Addendum – Pedestrian & Cyclist bridge Environmental Assessment Report

September | 2023

Iarnród Éireann
Irish Rail

The DART+ West project is seeking to significantly increase rail capacity on the Maynooth & M3 Parkway lines. This will be achieved by changing from diesel powered trains to electrified, high-capacity DART trains and increasing the frequency of trains from 6 to 12 trains per hour per direction. The hourly passenger capacity will increase from 5,000 to 13,200. The project will involve the electrification of approximately 40 km of permanent way (railway line) from the Dublin City centre to west of Maynooth and to M3 Parkway Station and all associated supporting infrastructure. The electrification of the rail line is located predominantly within the existing railway corridor within Iarnród Éireann/ Córas Iompair Éireann (CIÉ) owned lands however some works will involve the acquisition of private lands to facilitate the project. The principal project components are as follows:

Figure 1 - Parapet Design Representation 1

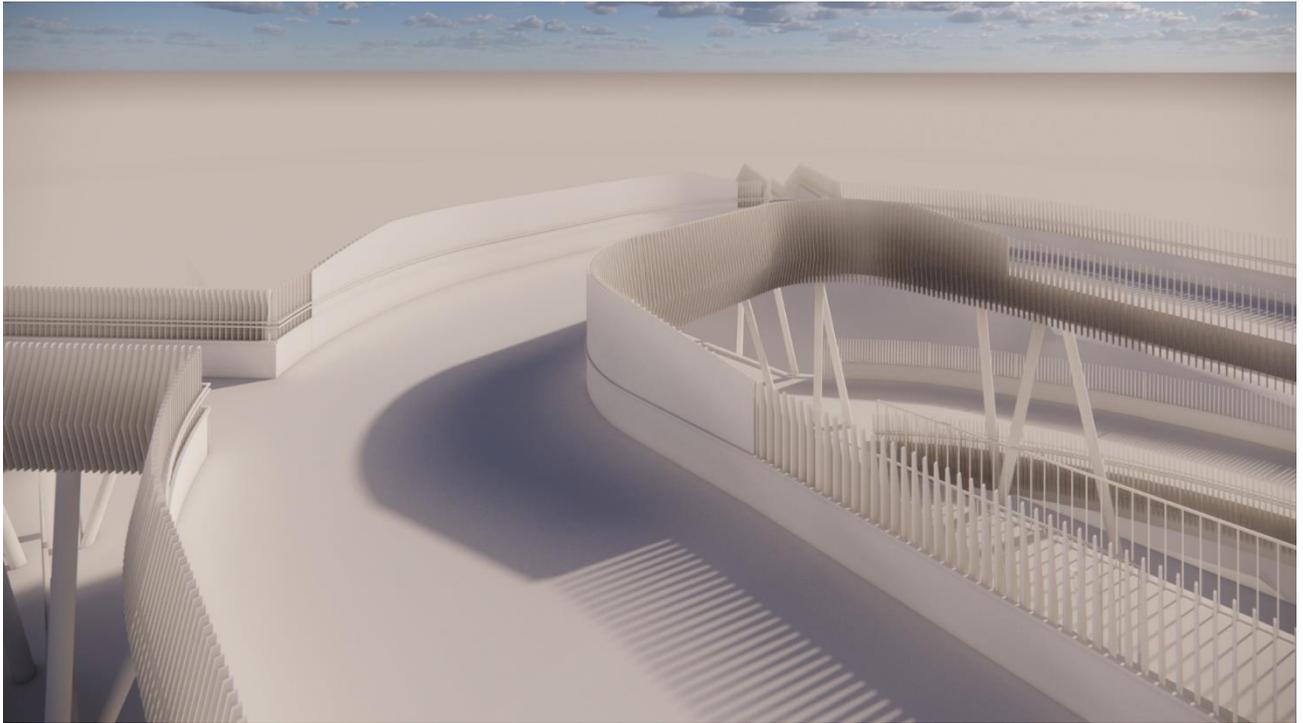
- 5.30m bridge clearance from TOR. (19% of reduction in bridge height)
- The proposed bridge length is 329 m, reducing 58 m from the draft RO design length (387m).
- 2 lifts incorporated (one on either side of rail)
- Slight amendments to stair access
- Improve transparency on parapets.

Figure 1 and **Figure 2** below are visual representations of how the design development to the parapets will look in the permanent situation.

Figure 4 Clonsilla footbridge proposal. No damming and dewatering of the Canal is required.

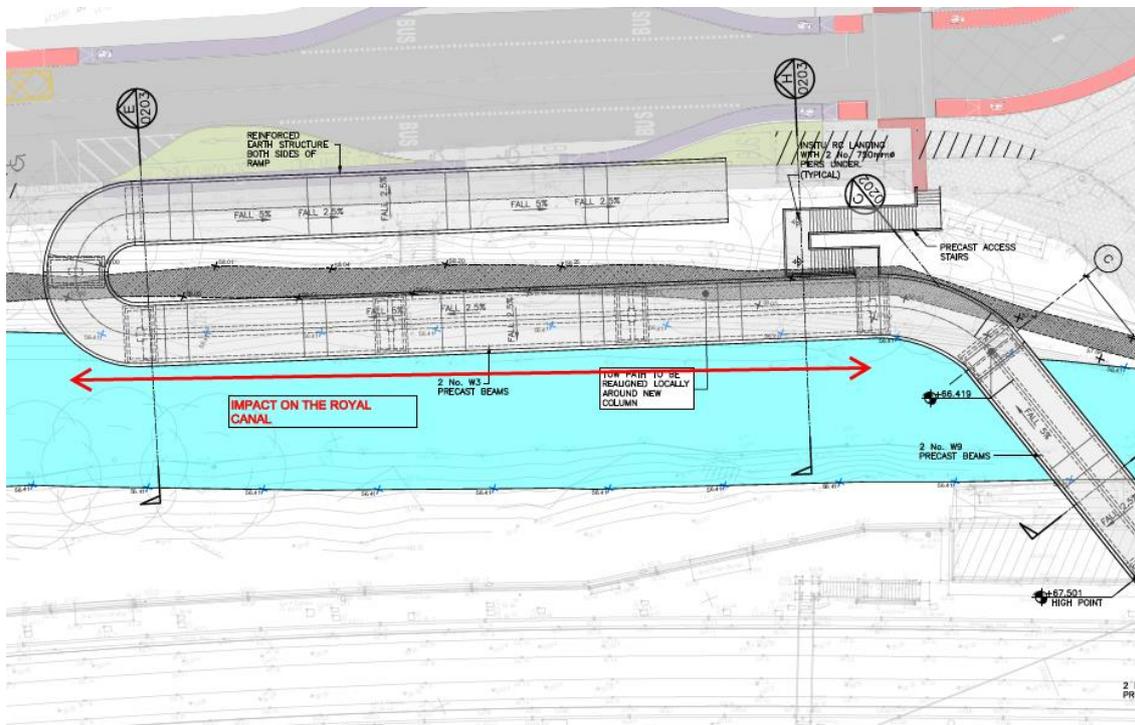
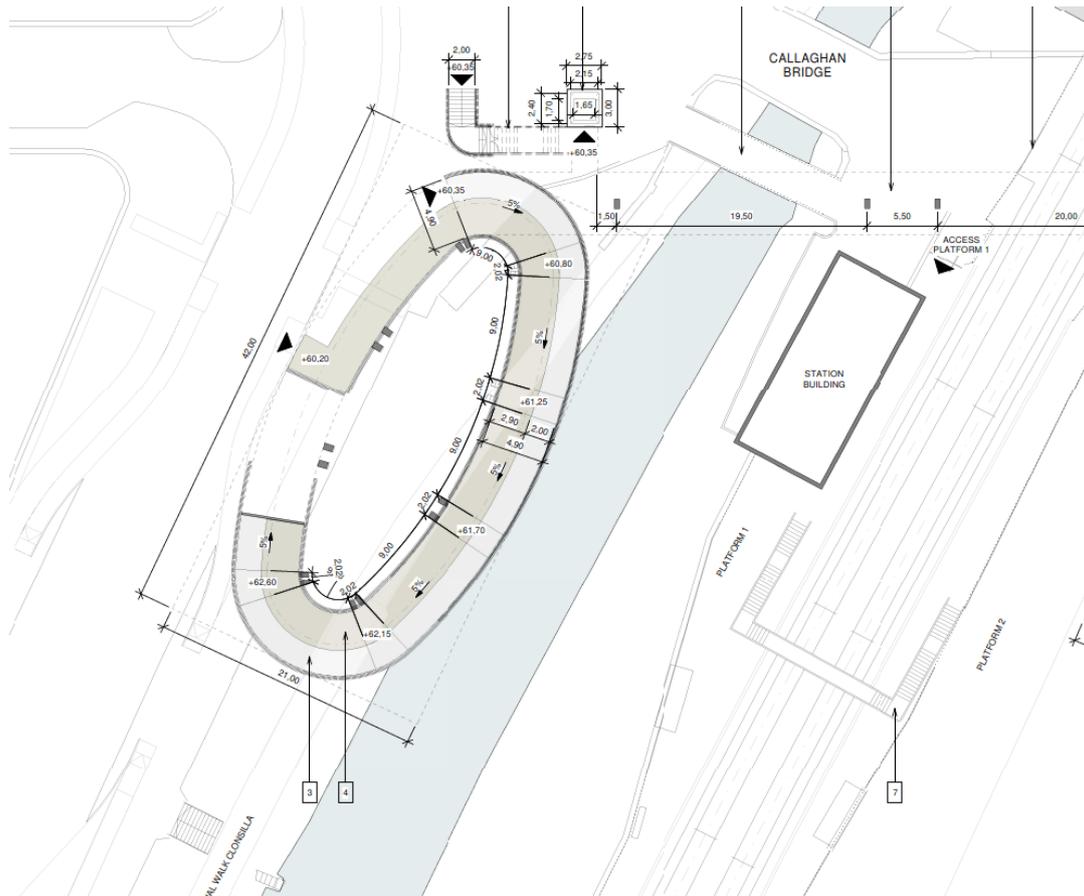
- **Figure 3 Draft RO design with 4 piles impacting the Royal Canal. Damming and dewatering the Canal are required.**

The proposal does not require damming and dewatering of the Canal but it still needs works around the Canal.

The construction strategy will not be very different from the draft RO prefabricated concrete structure solution (manufactured off-site) since the proposal will be for a type of steel structure, also manufactured in an off-site workshop.
